PCI Title : CHANGE OF SUPPLIER FOR 3CP40618 (CARRIER TAPE Wi 12mm QFN/LGA/PFLAT 5x5x1)

PCI Reference : CRP/22/12732

PCI - CHANGE OF SUPPLIER FOR 3CP40618 (CARRIER TAPE Wi 12mm QFN/LGA/PFLAT 5x5x1)

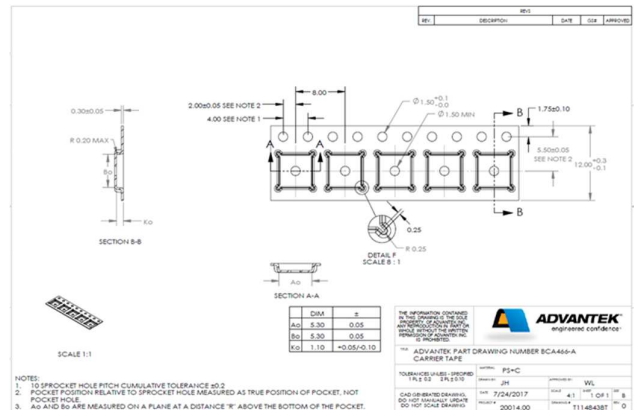
Change of supplier for ST material code reference: 3CP40618 (CARRIER TAPE Wi 12mm QFN/LGA/PFLAT 5x5x1) from PEAK to ADVANTEK which affected ST CALAMBA.

CURRENT: PEAK

NEW: ADVANTEK

APPENDIX 3: QUALIFICATION EXECUTION & RESULTS

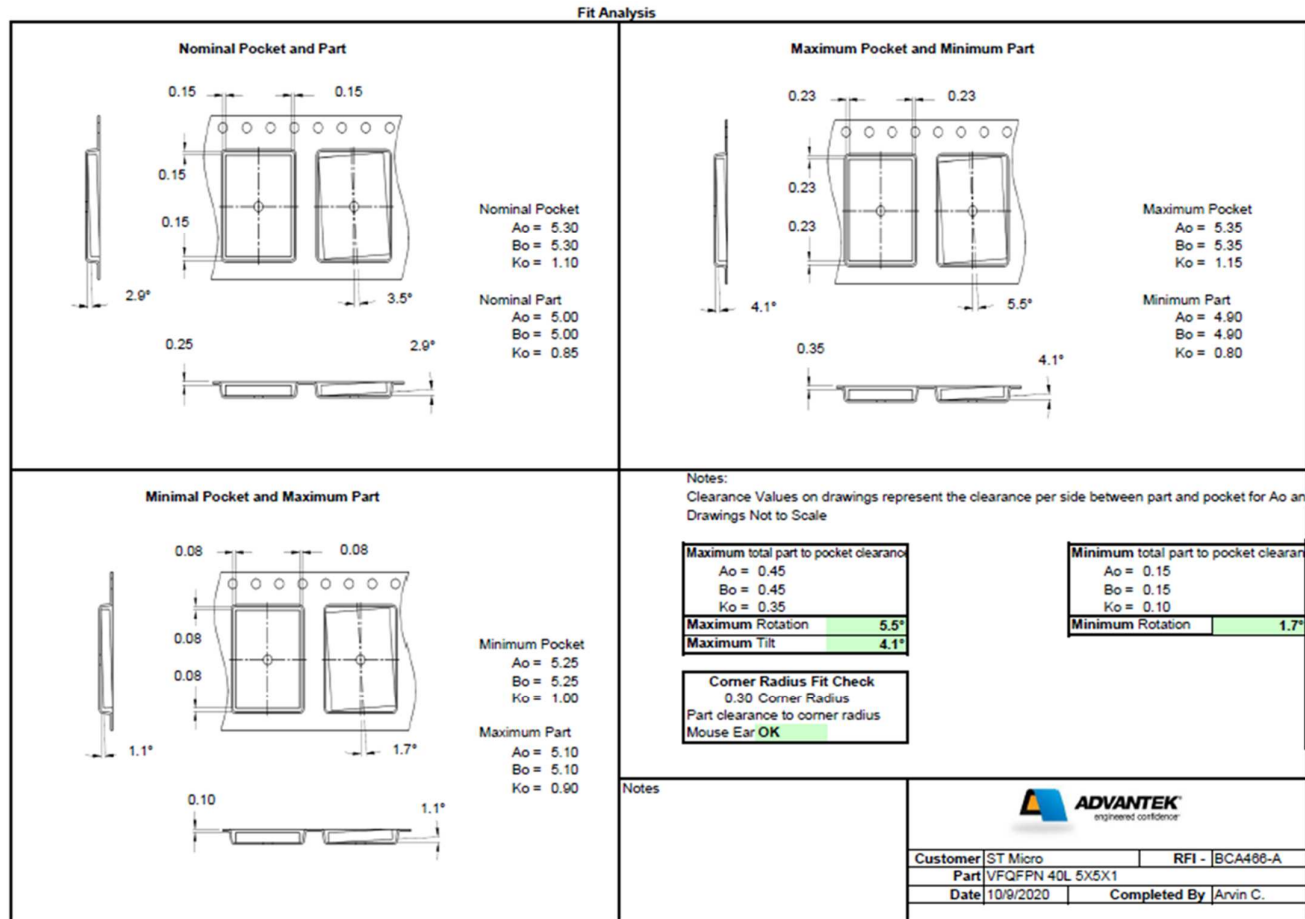
Visual inspection	Results
Does not contain stain or foreign material	Passed
No Damage	Passed
No Burr	Passed
Orientation	Passed
The component does not protrude above the top surface of the carrier tape	Passed
The component can be removed from the cavity in a vertical direction without mechanical restriction, after the top cover tape has been removed.	Passed
Lateral movement of the component is restricted to 1.0mm maximum	Passed

Test	Result
Drop Test Result	Passed
Peel Test Result	Passed
ESD Test Result	Passed

Based on above material qualification, the 12mm carrier tape from Advantek for QFN 5x5x1mm passed the Calamba requirement and can be used for normal tape and reeling process.
